# RENESAS TECHNICAL UPDATE

Product Category	MPU&MCU		Document No.	TN-SH7-A676A/E	Rev.	1.00
Title	SH7764 on-chip SSI (DMAC portion) trouble and additional notes of hardware manual (Rev1.0)		Information Category	Technical Notification		
Applicable Product	R5S77640P300BG R5S77640D300BG R5S77640N300BG R5S77641P300BG R5S77641D300BG R5S77641N300BG	Lot No.	Reference Document	SH7764 Group Hardware Manual (REJ09B0360-0100)		
		All lots

Please be informed of SH7764 on-chip SSI (DMAC portion) trouble and additional notes of hardware manual (Rev1.0).

Figure.1 DMAC trouble phenomenon

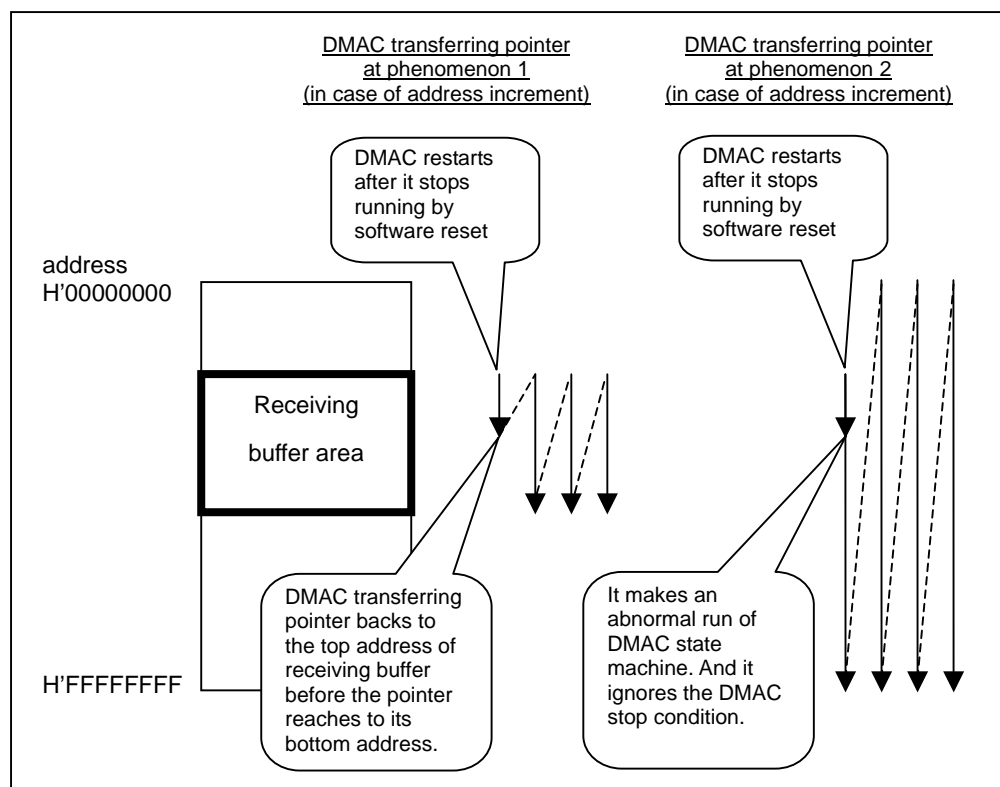
DMAC transferring pointer backs to the top address of receiving buffer (which is allocated on RAM) before the pointer reaches its bottom address. Please refer figure.1. As the result, the read address of the received data which software calculates by SSIBLCNT and SSIBLNCNT counters will be different from the transferring address of the received data by DMAC.

DMAC transferring pointer is incremented/decremented to outside of receiving buffer range. As the result, DMAC transfers data to outside of receiving buffer. Please refer figure.1. If you copy the program to RAM, DMAC transfer reaches to the area and it might make a system hung-up.

It is possible to make the countermeasure as followings operation, if you select 1-burst (8-byte) or 2-burst (16-byte) at WDMBSZ bit in SSIDMMR. Selecting 4-burst (32-byte) at this bit is prohibited.

- Clear RPTMD bit in SSIDMCOR
- Clear DMEN bit in SSIDMCOR
- Wait DMEND interruption or polling DMEND flag in SSIDMINTSR
- Clear DMEN bit in SSICR
- Clear EN bit in SSICR
- Set DMRST bit in SSIDMCOR
- Set RXRST bit in SSIDMCOR
- Clear RXRST bit in SSIDMCOR
- Restart SSI and SSIDMAC
